Sent: 05 September 2018 11:30
To: Charlotte Burrows
Cc: 'Alexia Brooke'
Subject: RE: Mayaro House, Hook Lane, Aldingbourne

I write to you regarding the recent application submitted at Mayaro House, Hook Lane – reference AL/76/18/HH. The application has now been passed onto me to deal with and I am starting to write the report.

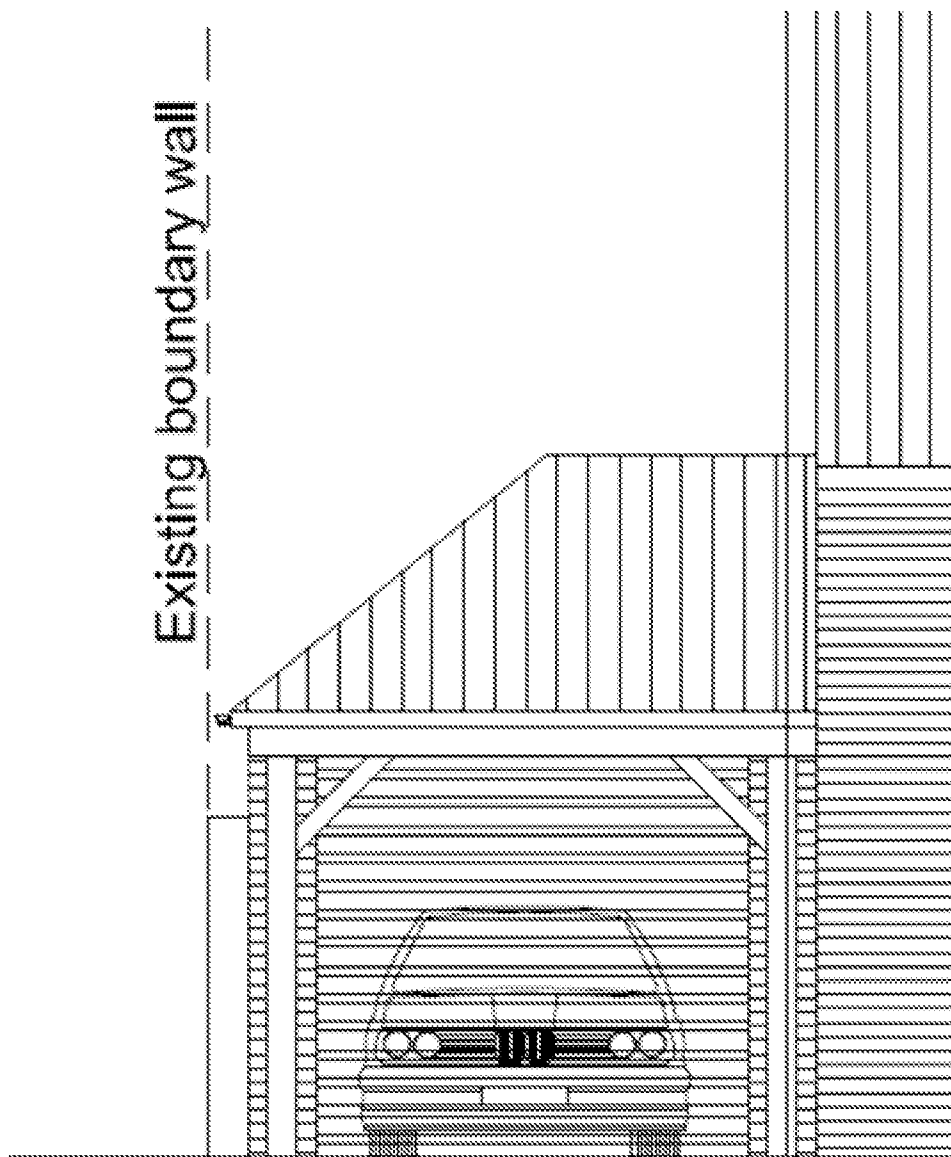
We have had an objection due to the fact the proposed roof appears to overhang the boundary wall. Could you please confirm if this is the case? If it is then please note you will be required to serve notice on the land owner of the adjacent path/road, amend the application forms submitted and then amend the red edge indicated on the location and block plan.

When I first became aware of this objection, I spoke to your colleague Amber Willard on Tue 21/08/2018 and explained that our proposal does not overhang the boundary wall. As you can see from the enlarged part-elevation / detail below, roof including the gutter is within applicant's property.

The boundary wall is in applicant's land, and it is owned and maintained by the applicant.
